BLUE BIRD

**SUBJECT: RECALL R09PD INCORRECT BOLTS AND/ OR SPACERS IN
ENGINE COOLING FAN**

Fan Clutch Spacers

MODELS AFFECTED: 2008-2009 BBCV Visions w/ 2007 Cat Engines

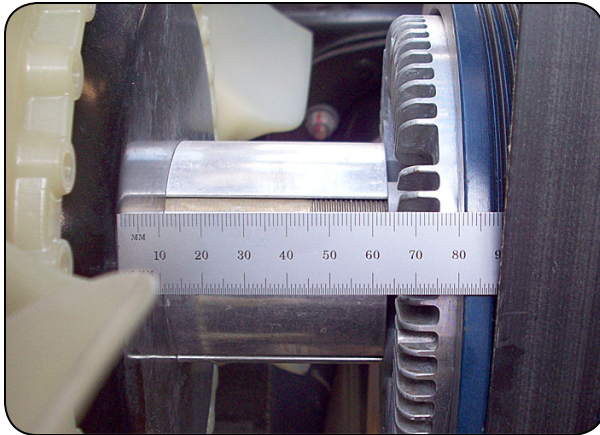
ISSUE

Fan may separate from fan clutch and may damage fans blades, fan clutch, radiator, hoses and other surrounding components.

CORRECTIVE ACTION

Inspect fan spacer length and install new spacer and bolts as required.

Inspection

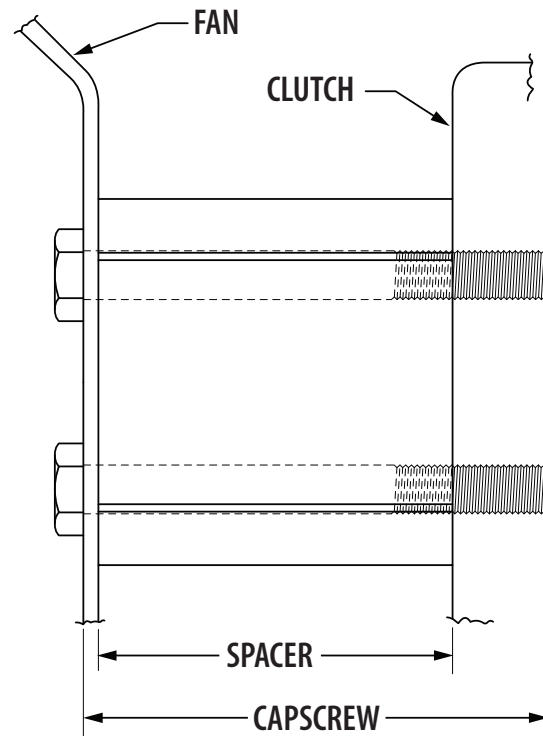
- 1** Park vehicle on a level surface, apply parking brake, turn engine off, remove ignition key and chock wheels.
- 2** Disconnect batteries.
- 3** Open engine hood.
- 4** Measure the length of the spacer between the fan blade and the fan clutch. See Diagram and Chart to the right for correct installations and determine procedure needed.

PROCEDURE 2 (with wrong spacer and wrong capscrews)
 For CAT C707 with CGI & DPF, and a 52.8mm (2 5/64 inch) spacer.
 Note: Caterpillar C707 with CGI and DPF has a Regen switch mounted on the entrance door side fire wall.

PROCEDURE 3 (with wrong spacer and wrong capscrews)
 For CAT C7 without CGI & DPF, or Export unit; with a 66.7mm (2 5/8 inch) spacer.

PROCEDURE 1 (with correct spacer and wrong capscrews)
 For CAT C707 with CGI & DPF, and a 66.7mm (2 5/8 inch) spacer.
 Note: Caterpillar C707 with CGI and DPF has a Regen switch mounted on the entrance door side fire wall.

ENGINE	SPACER	CAPSCREW
CAT C707 with CGI & DPF	66.7mm (2 5/8 inches)	90mm M10-1.5 X 90mm
CAT C7 or Export without CGI & DPF	52.8mm (2 5/64 inches)	70mm M10-1.5 X 70mm
